Reviewers' comments:

Uprooting defects to enable light-emitting III-V on Si

## Responses to Reviewers:

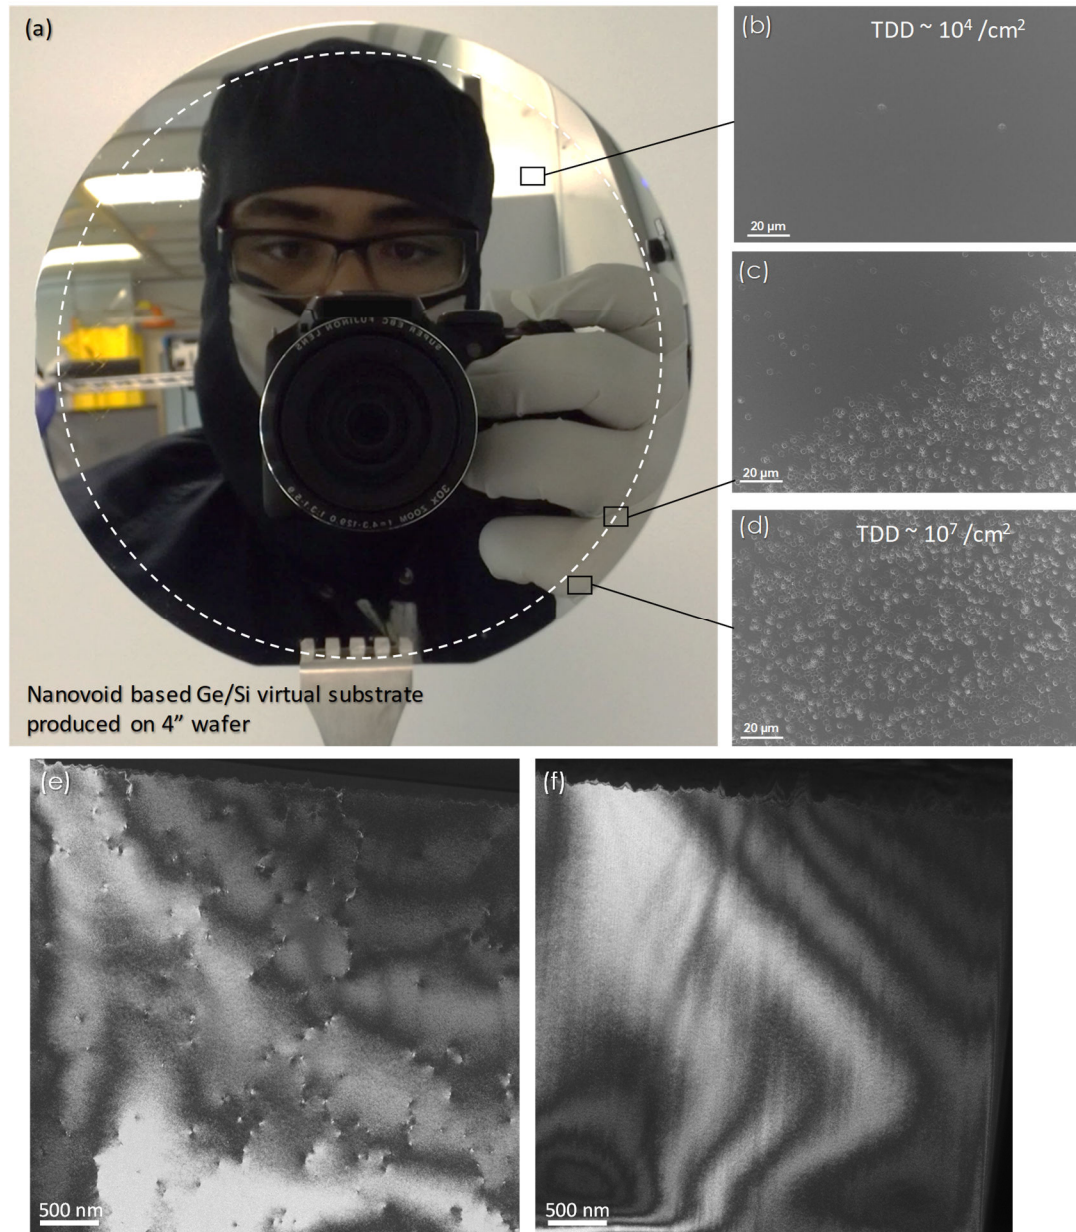
1) The claimed threading dislocation density (TDD) of  $1 \times 10^{-4} \text{ cm}^{-2}$  is remarkably low, and such a claim should be bolstered with a direct measurement of the TDD by, for example, plan-view TEM. The concern would be that etch-pits may only be revealing a fraction of the threading dislocations (TDs), and thereby providing only a lower-limit for TDD. For example, etch pits may only be revealing bunches of TDs in close spatial proximity, and not revealing isolated TDs. Etch pits may ultimately be the correct way to assess a very low TDD, but a one-to-one correspondence between TDs and etch pits needs to be solidly established for the reader.

CL data is also offered, but this is also an indirect measure of TDD, and it isn't clear if CL results can discriminate between (for example)  $1 \times 10^6$  and  $1 \times 10^4 \text{ cm}^{-2}$ .

**R2.1** The claimed threading dislocation density (TDD) of  $1e-4 \text{ cm}^{-2}$  is remarkably low, and such a claim should be bolstered with a direct measurement of the TDD by, for example, plan-view TEM. The concern would be that etch-pits may only be revealing a fraction of the threading dislocations (TDs), and thereby providing only a lower-limit for TDD. For example, etch pits may only be revealing bunches of TDs in close spatial proximity, and not revealing isolated TDs. Etch pits may ultimately be the correct way to assess a very low TDD, but a one-to-one correspondence between TDs and etch pits needs to be solidly established for the reader. CL data is also offered, but this is also an indirect measure of TDD, and it isn't clear if CL results can discriminate between (for example)  $1e6$  and  $1e4 \text{ cm}^{-2}$ .

The reviewer requests some data to substantiate the low threading dislocation density. In order to confirm the value claimed in this research, plan-view TEM analyses were carried-out as suggested. High quality plan-view TEM specimens were fabricated using a focused ion beam instrument. The planar sample-FIB preparation is composed of 4 steps: (i) machining a 3D piece onto the specimen surface in the selected area, (ii) the extraction of the 3D wedge containing the selected area, (iii) the planarization of the 3D form and (iv) the final cleaning step.

The threading dislocations density (TDD) can be more accurately determined from the plan-view TEM by estimating the dislocation density for a given area and repeating the process at a number of locations across the entire sample. Two samples were studied for comparison: a non-treated

Ge/Si substrate and a nanovoid-based Ge/Si substrate (NVS). From each sample, we analyze two TEM lamella taken from the edge and the centre of each substrate. The contrast in the images is dominated by thickness fringes and bend contours, which are inevitable in plan-view crystalline samples. Figure 6e and 6f below is a comparison between the TDD of two lamellae having an area of  $15 \mu\text{m}^2$  each, taken from these two substrates. The estimated TDD from the non-treated Ge/Si substrate is  $8.5 \pm 0.5 \times 10^8 \text{ cm}^{-2}$  compared to the estimated value of  $2.5 \times 10^7 \text{ cm}^{-2}$  obtained by EPD analyses (see the table bellow). This seems to confirm the point raised by the reviewer that etch-pits may only be revealing a fraction of the threading dislocations. The difference between these two techniques has been demonstrated by Kimerling's group which shows the high correlation between the threading-dislocation densities measured by plan-view TEM and EPD [8]. For the NVS, **no threading dislocation** is found in the areas as shown in Fig. 6f. Similar observations were obtained for the other pair of lamellae.

Non-treated Ge/Si substrate	Nanovoid-based Ge/Si substrate
plan-view TEM	$8.5 \times 10^8 \text{ cm}^{-2}$	$0 \text{ cm}^{-2}$ (within the limits of statistics)
EPD	$2.5 \times 10^7 \text{ cm}^{-2}$	$\sim 10^4 \text{ cm}^{-2}$

It is difficult, even with a plan view TEM image to measure a TDD of  $\sim 10^4 \text{ cm}^{-2}$  in a quantitative manner. At that level, the average distance between dislocations is of the order of  $100 \mu\text{m}$ . The fact that we did not observe any dislocations on our images should confirm that the actual TDD is at least an order of magnitude lower than  $10^6 \text{ cm}^{-2}$  (average distance of  $10 \mu\text{m}$ ). We therefore argue that the TDD of  $\sim 10^4 \text{ cm}^{-2}$  obtained by the EPD technique is reasonable when compared with other results from the same technique in the literature, even though a more accurate figure remains to be defined. In order to clarify this point, we have added the following sentences in the last paragraph of section 2.2:

For the reviewers' information, we include plan-view TEM of two samples: non-treated Ge/Si substrate and the NVS in Figure 6.

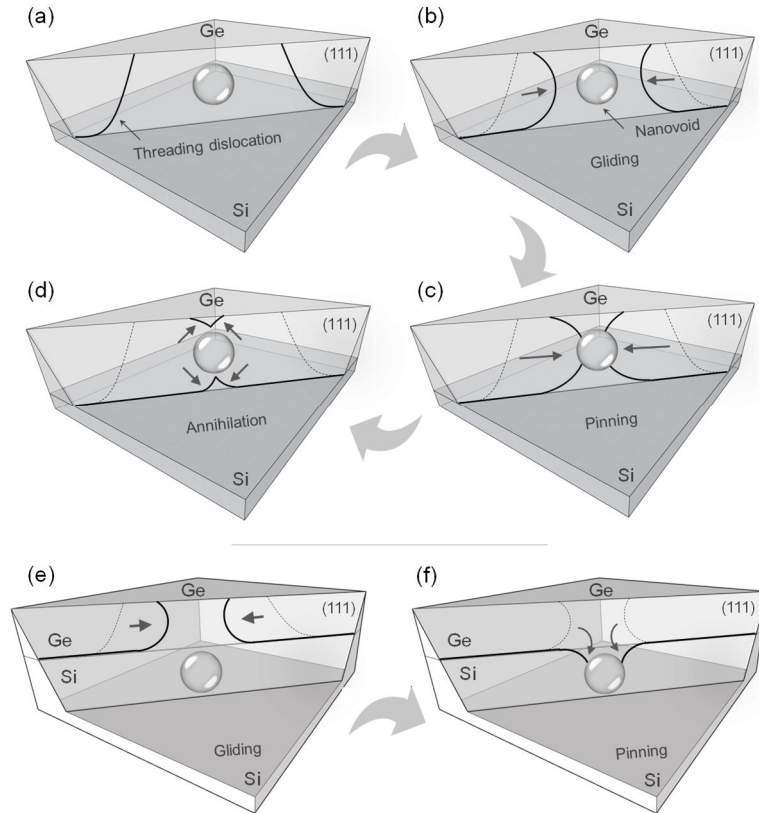
For example (lines 274-276) "In Si, TDs bend into the glide plane towards the voids in Si onto the glide plane in order to minimize their length, causing their elimination at the nearest free surface." It should be possible to illustrate this sentence with a topologically correct sequence of diagrams, and doing this should ultimately help explain how the TDD at the top of the Ge layer is reduced. If this can't be done, consider omitting this sentence, and many other similar sentences.

b) Rewrite all subsequent associated text describing this process. If this can't be done, then it would be best to provide instead a brief discussion of possible dislocation annihilation mechanisms, along with an acknowledgement that the full process is not understood at this point. This same advice applies to all of the subsequent statements about dislocations in the paper. For example (lines 274-276) "In Si, TDs bend into the glide plane towards the voids in Si onto the glide plane in order to minimize their length, causing their elimination at the nearest free surface." It should be possible to illustrate this sentence with a topologically correct sequence of diagrams, and doing this should ultimately help explain how the TDD at the top of the Ge layer is reduced. If this can't be done, consider omitting this sentence, and many other similar sentences.

As suggested, we have added a new figure (Fig. 4) in the manuscript, which schematizes possible dislocation annihilation mechanisms by the voids. For the sake of clarity, only one  $\{111\}$  glide plane is drawn. Figure 4a-4d show possible TD-removal mechanisms with void located inside the Ge layer, while Figure 4e and 4f show TD-removal when the void is located in Si substrate. In order to convey this in the manuscript, the following text has been added in the discussion of "Dislocation Annihilation Mechanisms and Crystal Quality":

“Figure 4 proposes a descriptive sketch to explain the phenomena of the annihilation of dislocations in Ge epilayer grown on Si substrate by introducing nanovoids. For the sake of clarity, only one  $\{111\}$  glide plane is drawn. The heat treatment stimulates the propagation of dislocation loops along glide planes (Fig. 4b). The dislocations with opposite Burger vectors move easily and react with each other (Fig. 4c), since it can occur in the same glide plane  $\{111\}$ , without the need of any extra point defect supersaturation for climbing. Thus, the threading components disappear (Fig. 4d).”

“The analog is also present in Si, where TDs originating from the interface bend downwards and move along the glide plane towards the voids in Si in order to minimize their length. Their elimination in pairs is also possible within these voids. A descriptive scheme of this phenomenon

*leading to the reduction of TD density when using a voided Si template is given in Figure 4e and 4f.”*

Figure 2: Schematic illustration of the interaction of singular screw dislocation by one void. The exit step, characterized the initial screw dislocation, is taken up by the lower and the upper parts of the inner void surface (please see Fig. 6 of the reference [30]).

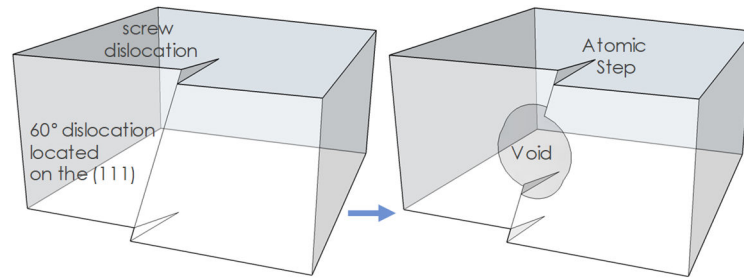
4) 'For large voids that are sufficiently spaced out, dislocation can bypass the obstacle via the Orowan mechanism.'

This is wrong, this doesn't occur for voids. 'Orowan mechanism means' the formation of a dislocation loop around the obstacle. However, in this case (a void) the segment of the dislocation that meets the void will disappear in the void (making a step in the internal surface; this step has

the amplitude of the Burgers vector of the dislocation). Actually, a dislocation is attracted by the internal surface of the void: as this surface is a free surface, it induces image forces on the dislocation that attract the dislocation. The dislocation therefore will not stop before the surface of the void and thus cannot form an Orowan loop around it.

To avoid any confusion, we deleted the sentence that mentions Orowan loops.

2/ We agree with the reviewer that the dislocation does not form a loop around the void but it penetrates the void forming an atomic step inside the inner surface, as schematize in Figure 2. The dislocation will not disappear in the void because it is topologically impossible. The reduction of the dislocation density is explained in the rest of the text by the interaction of opposite dislocations through the voids.

Figure 4: Schematic graph of the annealing cycle that the NVS has undergone in order to test its mechanical integrity.

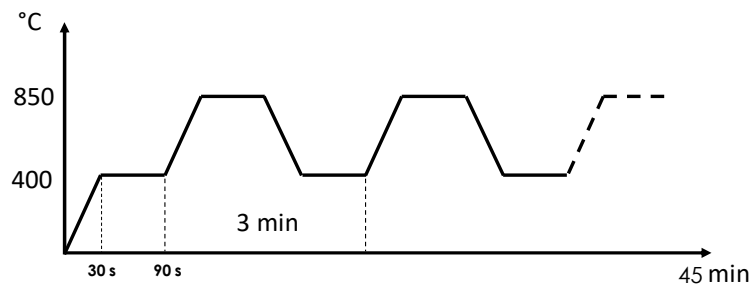
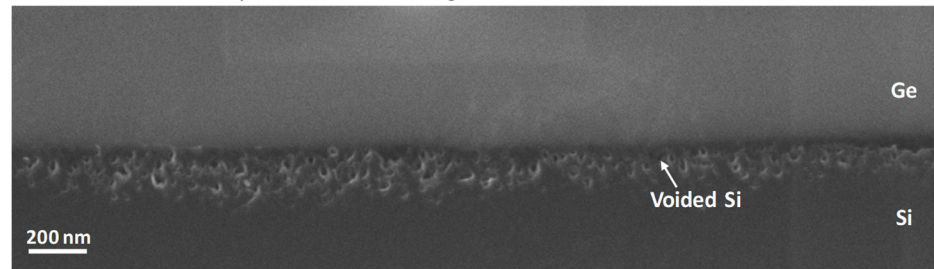
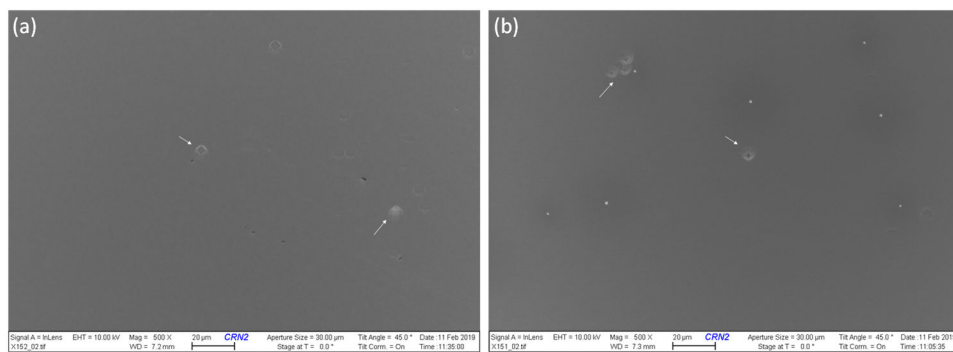
**R3.5** Page 10: 'Due to its porosity, the elastic modulus of Si is reduced and the substrate can be stretched, compressed, and deformed. It is therefore expected to accommodate the mismatch of heterogeneous layers and to serve as a mechanically stretchable compliant substrate.'

Did the author checked the mechanical integrity? uthors should really check the mechanical integrity of the resulting device. Such an array of nanovoids introduces a fragilized area that may lead to the premature failure of the whole device during transport and handling. Authors should add a comment in the text about this point.

With regards to the comment about how the mechanical properties of the porous substrate affect the integrity of the resulting device, we have not conducted a complete study on these ourselves. Indeed, many other groups have studied the heteroepitaxy on porous silicon and devices were obtained, though most do not specifically discuss the mechanical integrity [35].

In order to test the mechanical strength of the resulting substrate and its reliability in the reduction of the dislocation density, we carried out a cyclic annealing test.

Annealing of the NVS samples was performed in a gas ( $N_2: H_2$  90:10) ambient using a J.I.P. ELEC JetFirst rapid thermal annealing system with a ramp rate of  $15^\circ C s^{-1}$ . The annealing temperature pulses and their duration are respectively  $800^\circ C$  for 1 min and  $400^\circ C$  for 1 min. The duration was fixed at 45 min, as shown in Fig. 4.

After cyclic annealing, cross-section SEM image of NVS sample shows that the Ge/voided Si interface remains intact, with a slight increase of the void size in Si, due to the coalescence of small voids at high temperature (see Fig. 5).

Optical microscope inspection did not present any cracks on the top surface despite the thermal stress. This confirms that the Ge layer was not damaged or delaminated.

The dislocation density was also verified and etch-pit density (EPD) analyses were carried-out on the NVS sample before and after the cyclic annealing using the same etching solution described in the manuscript. It has been shown by SEM images in Figure 6 that the TDD after annealing remains almost identical to that without annealing, which confirms that the dislocations remain effectively blocked from propagating in the NVS.
